Re: *Supplemental Remedial Investigation Work Plan (RIWP)*
NYS Brownfields Cleanup Program
Hamilton Hill II – Target Area 1 Site
830 and 834 Albany Street Parcels
City of Schenectady, Schenectady County
BCP Site No. C447052

The purpose of this Supplemental RIWP is to address the New York State Department of Environmental Conservation's (NYSDEC's) June 12, 2019 comments to the RI Report related to data gaps pertaining to comments 1, 4, 15 and 17 concerning the following areas:

FIGURE 2: SITE FEATURES MAP

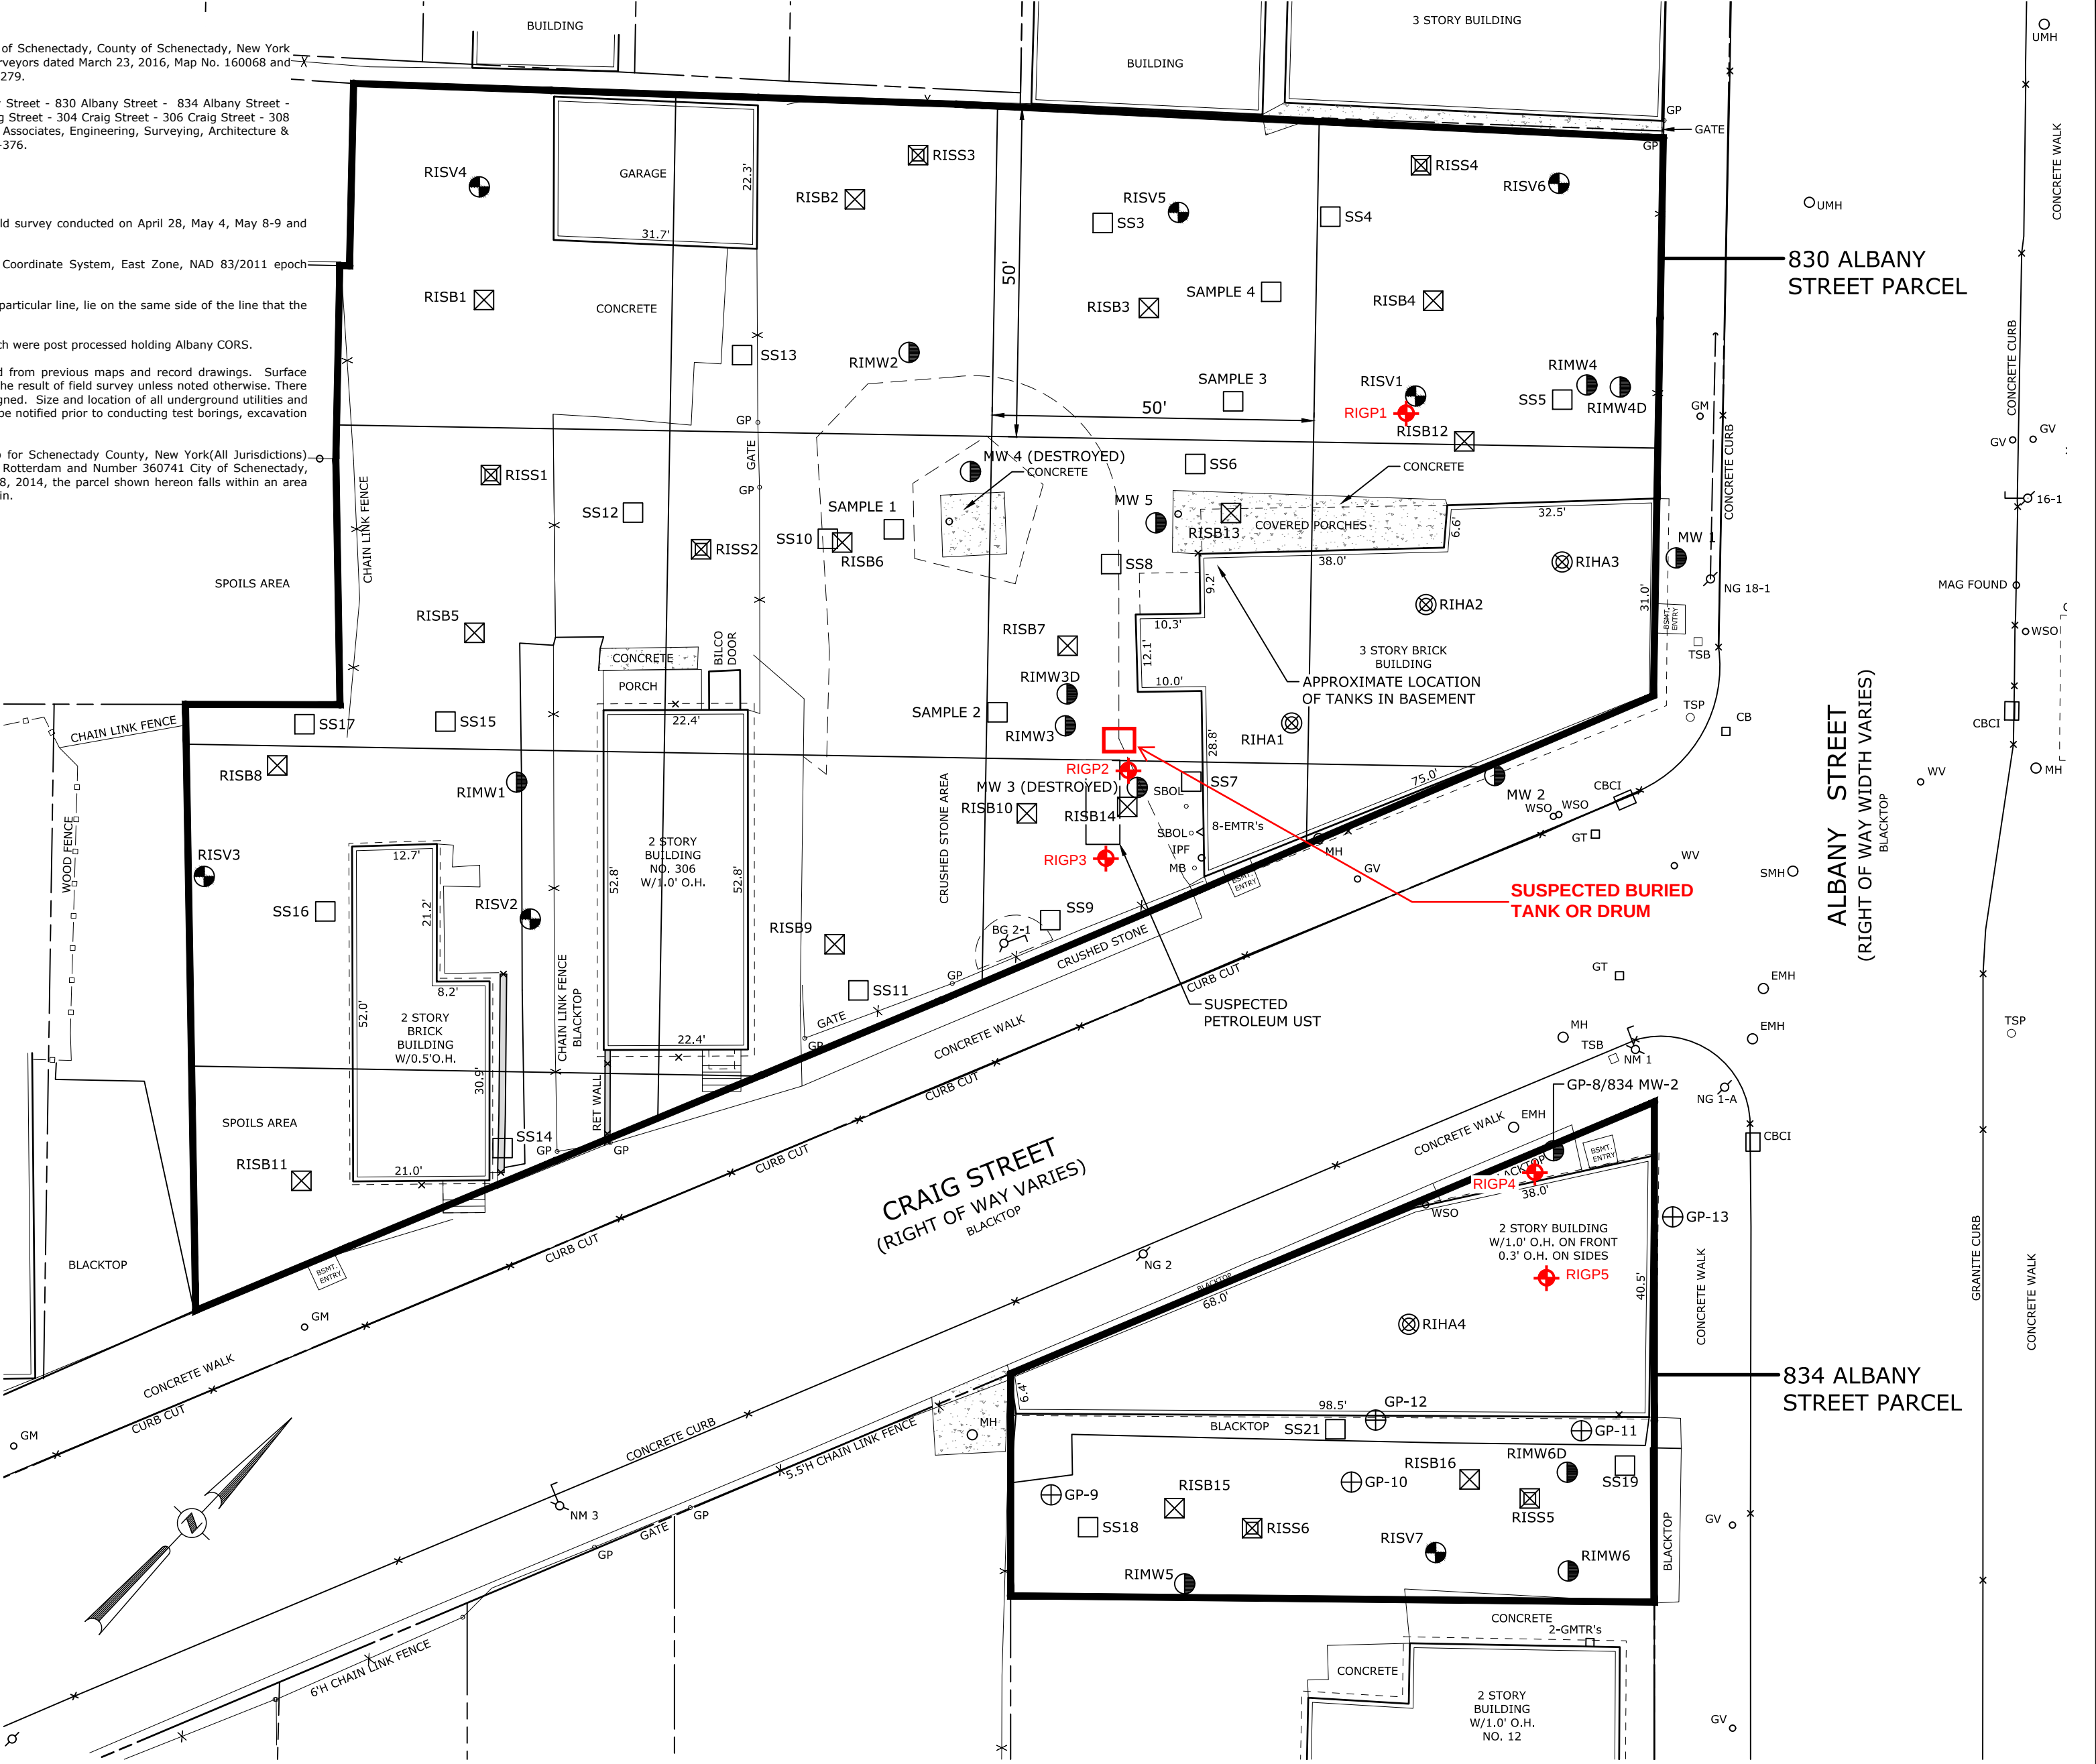
- The northwestern portion of the 834 Albany Street Parcel (Comment No. 1): Due to the presence of utility lines and the former site building, a planned boring (RIMW6D) was unable to be advanced in this area.

- Potential drum/tank and known underground storage tank (UST) on the 830 Albany Street Parcel (Comment No. 4): Although test borings were completed near these features, based on the direction of groundwater flow as determined during the RI, the borings were not advanced in positions down-gradient from these features.

- Area of RISV1 on the 830 Albany Street Parcel (Comment Nos. 15 and 17): Elevated soil vapor results and photoionization detector (PID) results were recorded at RISV1, a soil vapor point advanced as a function of the RI. As RISV1 was advanced for the purpose of collecting a soil vapor sample, soil samples were not submitted for laboratory analysis from this sample location.

- RIGP1 will be advanced in proximity to RISV1 on the 830 Albany Street Parcel.
- RIGP2 will be advanced to the eastern and down-gradient side of the suspect buried drum/tank on the 830 Albany Street Parcel.
- RIGP3 will be advanced to the eastern and down-gradient side of the suspect petroleum UST on the 830 Albany Street Parcel.
- RIGP4 will be advanced on the northwestern portion of 834 Albany Street Parcel.
- RIGP5 will be advanced within the northwestern portion of the former building foundation on the northwestern portion of the Albany Street parcel. If the Geoprobe is unable to enter the foundation area, RIGP5 will be advanced using and auger or dolly mounted Geoprobe.

One (1)-inch diameter monitoring wells with PVC slotted screens and risers will be installed in soil borings RIGP1 through RIGP5 (see the attached Remedial Investigation Plan). The screened portion of the monitoring well will straddle the water table approximately five feet above and five feet below the water table. A filter sand pack will be installed from the bottom of the borehole to at least 1 foot above the top of the well screen. The monitoring wells will be finished with a surface seal and protected with lockable protective enclosures. Samples submitted for laboratory analysis from the newly installed monitoring wells will be analyzed for the contaminants of concern for each area. Specifically:
